Addendum 01

Date: September 23, 2011

Regarding: **Elm Terrace** – Portland, Maine

Subject: **Addendum 01**

Wright Ryan – Site & Building Shoring Extents Plan

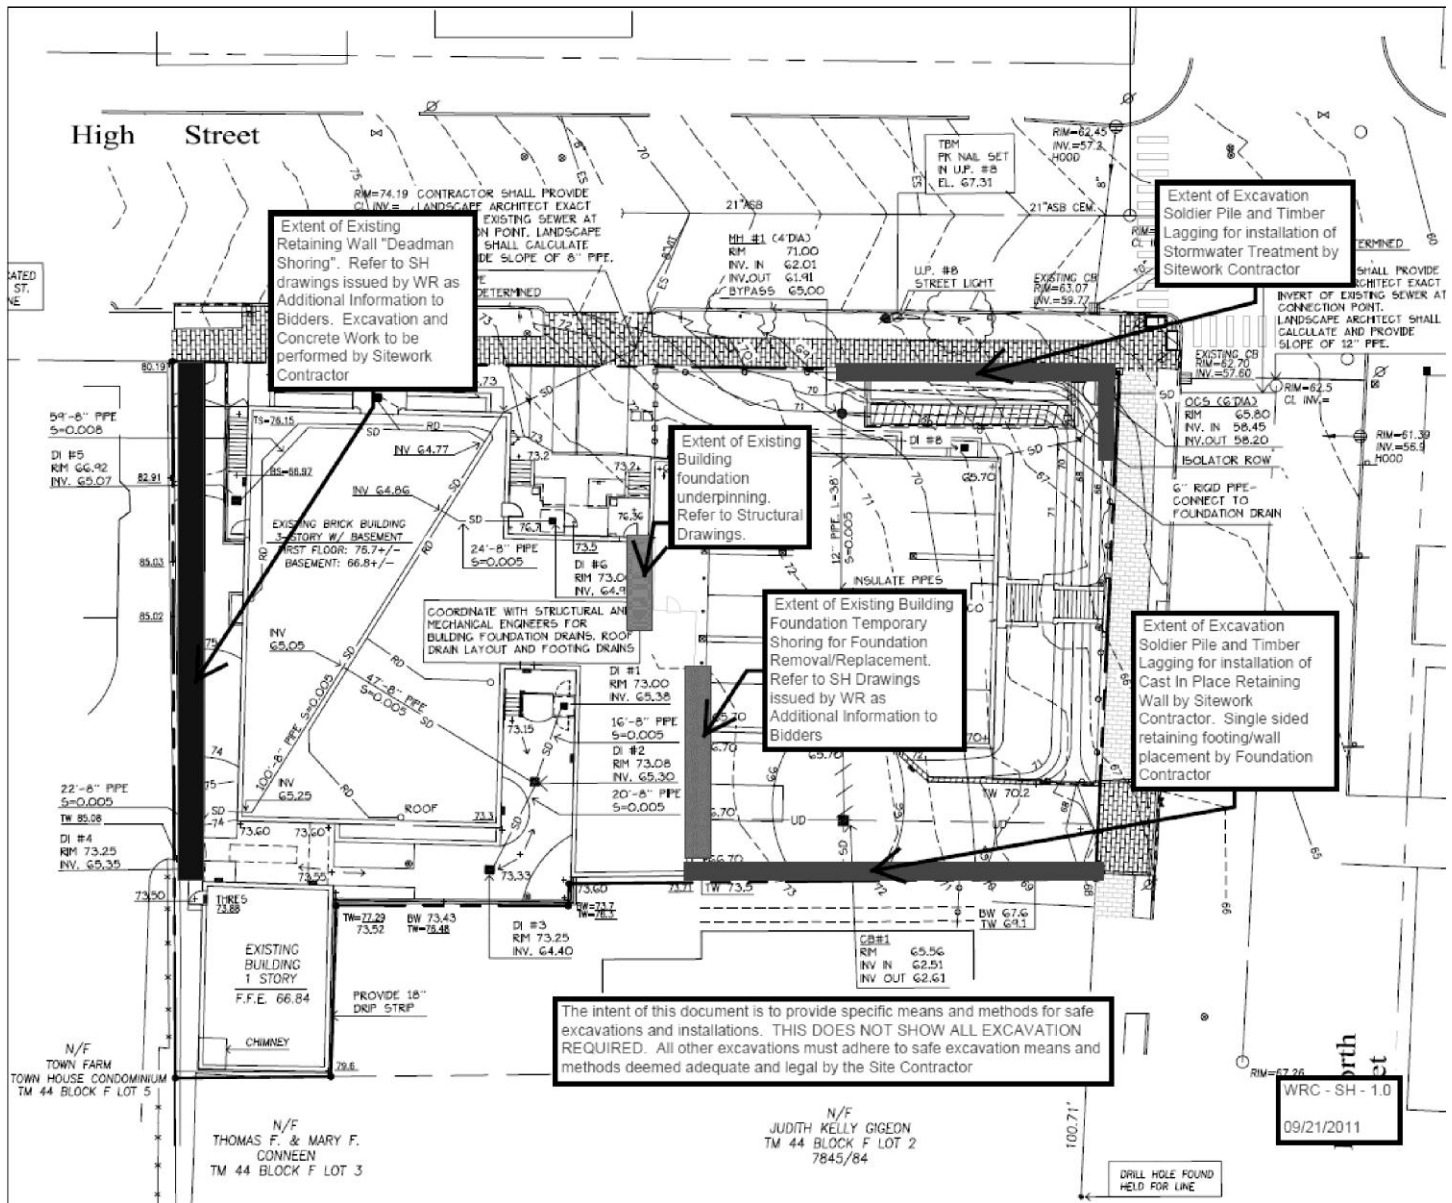
This document serves as additional instructions to potential subcontractors as it pertains to Site and Building Shoring.

- Shoring of existing building
 - Work is to be priced in accordance with documents included in Addendum 1 as additional information available to bidders
 - Substitute approaches will be entertained post bid
- Shoring of existing retaining wall
 - Work is to be priced in accordance with documents included in Addendum 1 as additional information available to bidders
 - Substitute approaches will be entertained post bid
- Excavation Shoring
 - Work is to be priced in accordance with documents included in Addendum 1 as additional information available to bidders
 - The design intent assumes the use of Soldier Pile with Timber Lagging
 - Vibratory Sheet Pile is not permissible.
 - Substitute approaches will be entertained post bid
- All other excavation support measures not indicated on the documents shall be the responsibility of the sitework contractor.
